Geotechnical and Geological Review

Project: Nobs Hillside Review
User: Alan Taylor
Department: Taylor Geotechnical
Created: 2015-05-29 23:45:51
Modified: 2015-05-30 05:30:42

Subect Document: Earthtec Engineering: "Geotechnical Study, Lot 15 Ski Lake Estates No. 3, 6640 East 1100 South, Huntsville, Utah," Project No. 145150G, prepared for Martin Nobs, dated June 23, 2014.

Subject: Report - Geotechnical Study, Lot 15 Ski Lake Estates No.3, 6640 East 1100 South,
Huntsville, Utah, prepared by Earthtec Engineering Inc. (project no. 145150G), dated June 23, 2014, prepared for Mr. Martin Nabs, 50 River Bluff Road, Elgin, IL 60120.

Memorandum
Lot 15 Ski Lake Estates No.3
6640 East 1100 South, Huntsville, Utah

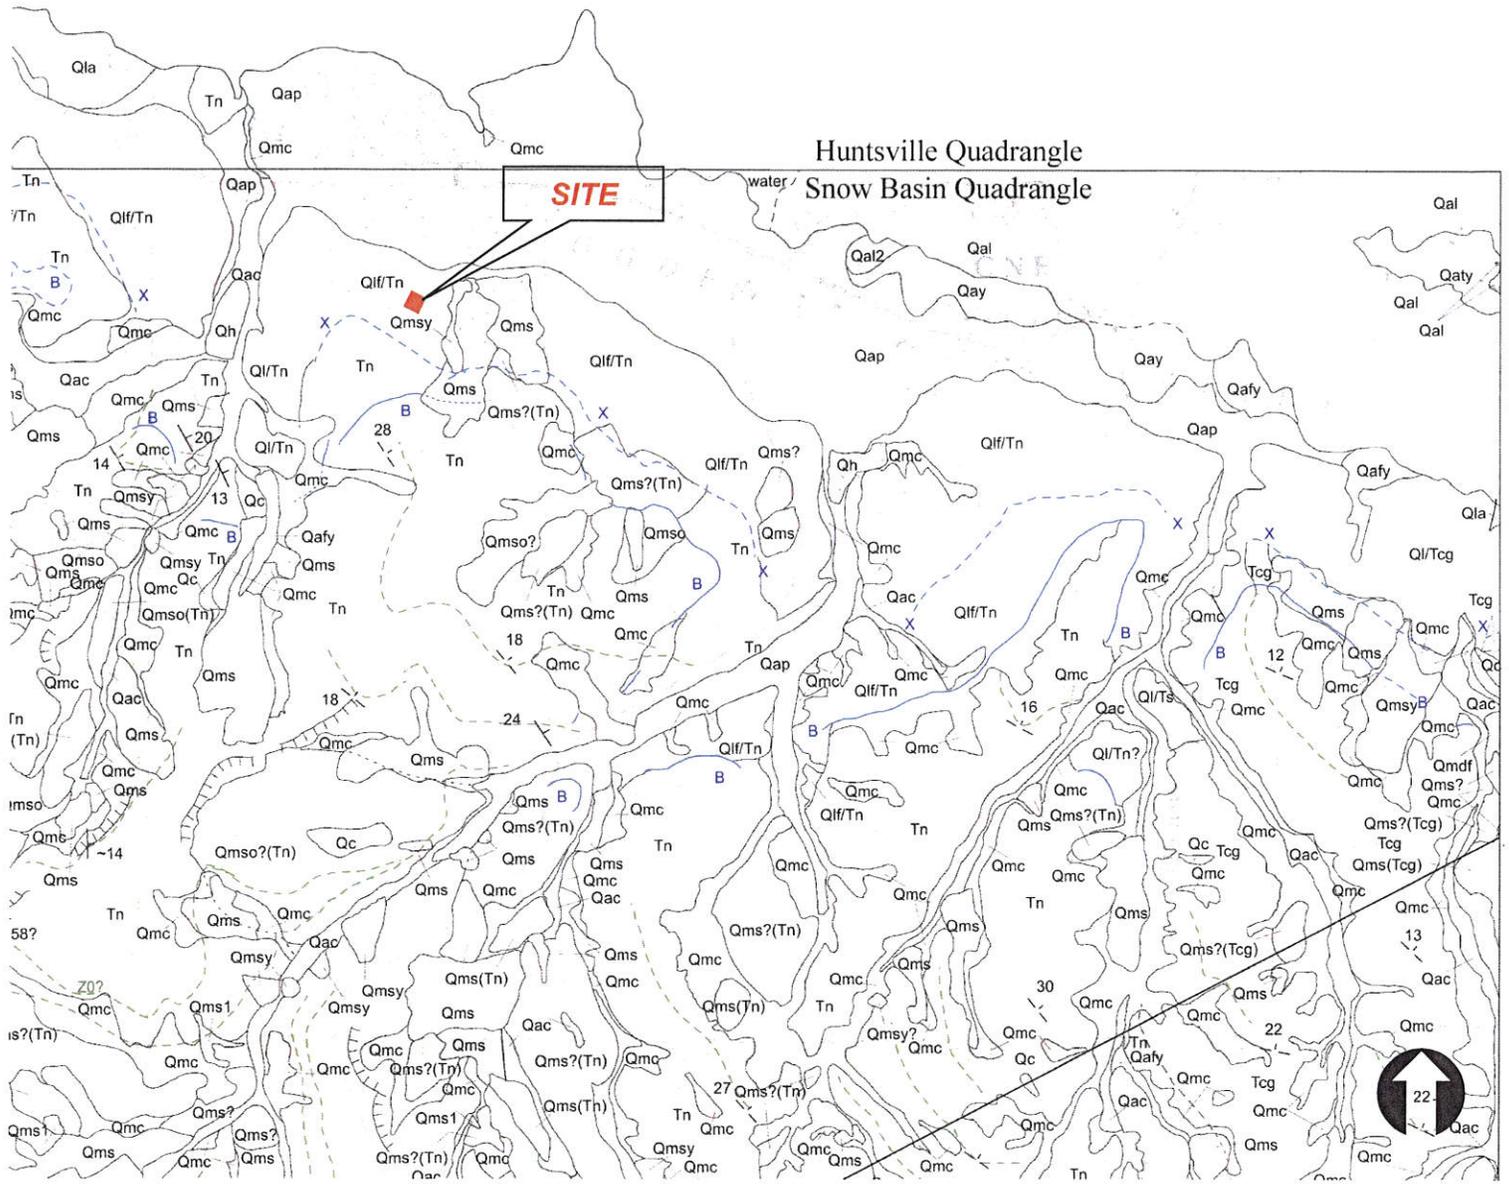
As requested I reviewed the above referenced report to evaluate whether or not the site is located in a geologically sensitive area. It is my opinion the site is located in a geologically sensitive area. As shown on the attached geologic map:

1. The site is underlain by geologic unit Tn, Norwood Formation, an extremely landslide-prone geologic unit. Personally, I believe any site underlain by Tn should have a qualified engineering geologist, at a minimum, review, if not log, subsurface explorations.
2. There are several landslides in the immediate vicinity of the site (geologic unit Qms), all within unit Tn. Please note that I only included the geologic description of the units in the immediate vicinity of the site on the attached geologic map.

Based on the documents reviewed and my experience in the area, specifically with the Norwood Formation, I recommend the site be treated as a geologically sensitive (e.g., hazardous) site and also be evaluated by a qualified engineering geologist. Should you have any questions, please feel free to contact me.
